SUBJECT: SAFETY RECALL OF SE-GI WINDOWS

Ref.: **NHTSA # 10V-373**
TRANSPORT CANADA #TC 2010-270
MCI Service Bulletin 348

Service Bulletin No. 348

MODEL E4500 / J4500 Series Coaches	TYPE Field Change Program	SECTION/GROUP 3-Body	DATE Aug. 16, 2010
SUBJECT SE-GI WINDOW GLASS ASSEMBLY ADHESIVE DEBONDING			
CONDITIONS

Figure 1.

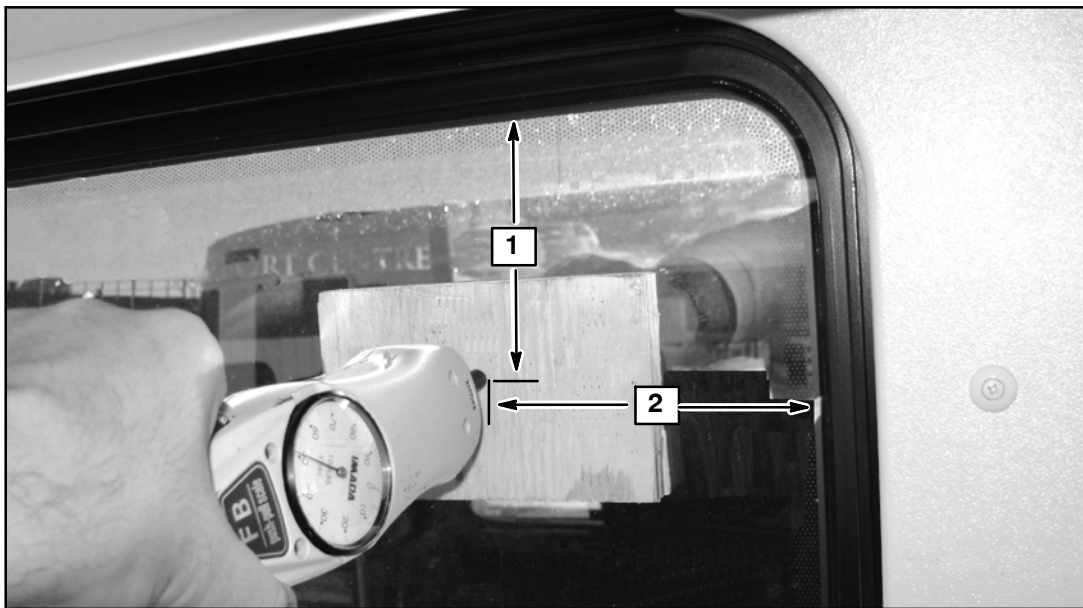
3. Ensure window is in locked position.
4. From inside the coach, carefully position a 4.0 x 4.0 x 0.5 inch flat wood block flat against the glass surface, the center of which should be six (6) inches from both edges (as shown in Figure 1). Position a push / pull gauge at the center of the wood block and apply 50 lbs. push force against the glass, perpendicular to the glass surface, to accentuate any partial de–bonding that may exist.
5. Look for any evidence of de-bonding from the frame, as force is applied.

6. Repeat Steps 3. to 5. at the remaining three (3) corner locations of the window.
7. Repeat Steps 3. to 6. to remaining coach windows.
